DOE Response to EPA Question SDI(HCR)-1 on the SDI Planned Change Notice

Figure 1. Preliminary Temperature Distribution for the Proof-of-Principle In Situ Field Test

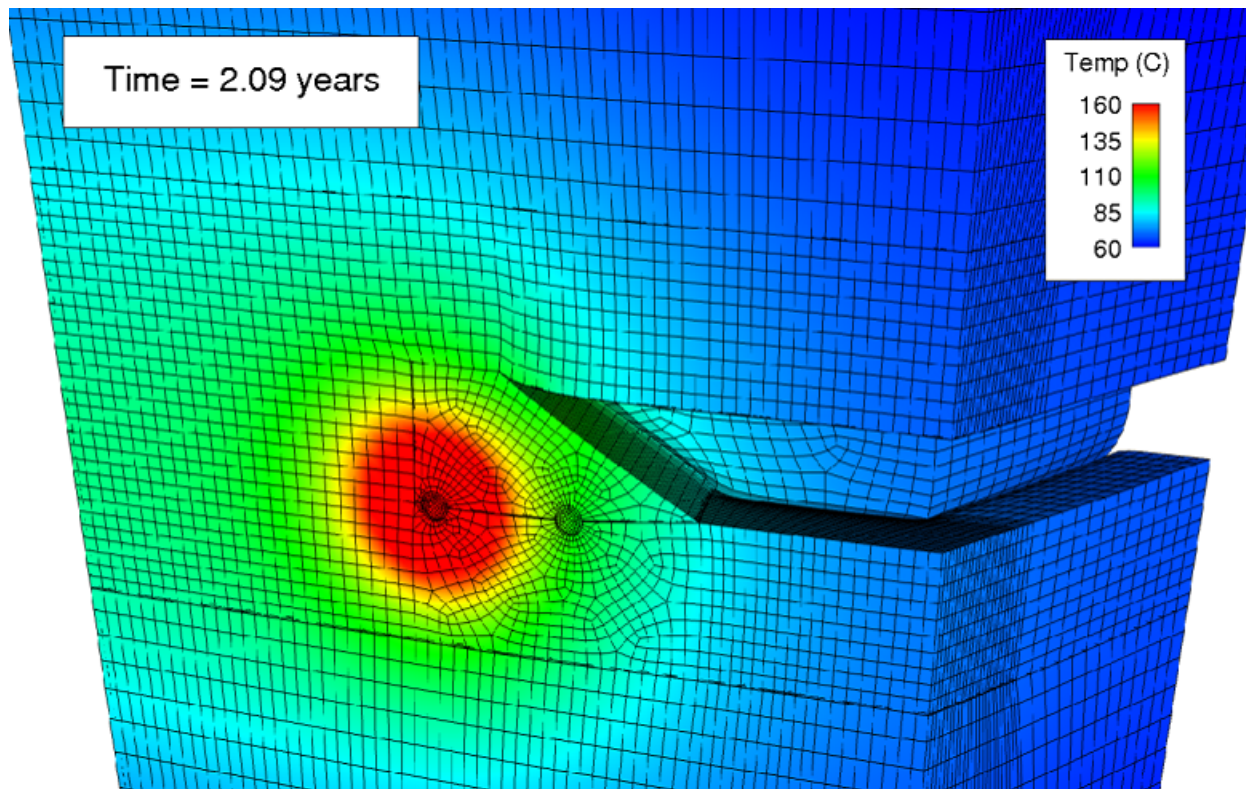
SDI(HCR)-1: Please provide information on the expected effects of convectively transported heat from the planned SDI heater tests on the lower portion of the WIPP exhaust shaft.

Background: Convectively transported heated air from the SDI tests could be conductively transferred to the halite along the perimeter of the exhaust shaft, potentially altering shaft geometry and disrupt or reduce the operational lives of the shaft. We would expect the area of greatest impact, if there were to be any, to be at the base of the exhaust shaft. Because the exhaust shaft is used by the SDI test as well as the rest of the underground facility, any impacts on the functionality of this shaft could impact waste disposal operations.

Even if ventilation is not blocked during the heating phase, convectively transported heat from the SDI heater test will be minimal. Detailed thermal analyses were performed for a generic salt repository with hot waste canisters in alcoves that are partly filled with crushed salt. These thermal analyses are relevant to the SDI test because the physical configuration for the SDI test is patterned after the design of this generic salt repository. Figure 1 is a plot of the temperature distribution around a hot canister at 2 years after emplacement, which is the duration of the heating phase of the SDI test. This figure shows that the heat energy is concentrated in the intact halite and crushed salt surrounding the hot canister. The walls of the access drift, on the right-hand side of Figure 1, remain cool relative to the hotter salt surrounding the hot canister. In this situation, heat transfer from the walls of the access drift to any ventilation air flowing in the access drift will be minimal, and the convectively transported heat from the SDI heater test to the lower portion of the WIPP exhaust shaft will also be minimal.

Section 2.1.3 of the SDI Planned Change Notice (PCN) calculates an upper bound for the temperature change from the SDI heaters in the ventilation air stream in the exhaust shaft. This calculation is an upper bound because it assumes that all of the thermal power from the 5 SDI heaters, 42.5 kilowatts, is added to the ventilation air flow in the exhaust shaft. In other words, heat transfer from the SDI heaters to the ventilation air stream is 100% efficient, and no heat remains in the salt. This is obviously a very conservative upper bound because most of the heat from the SDI heaters remains in the intact halite and crushed salt, as shown in Figure 1 and discussed above.
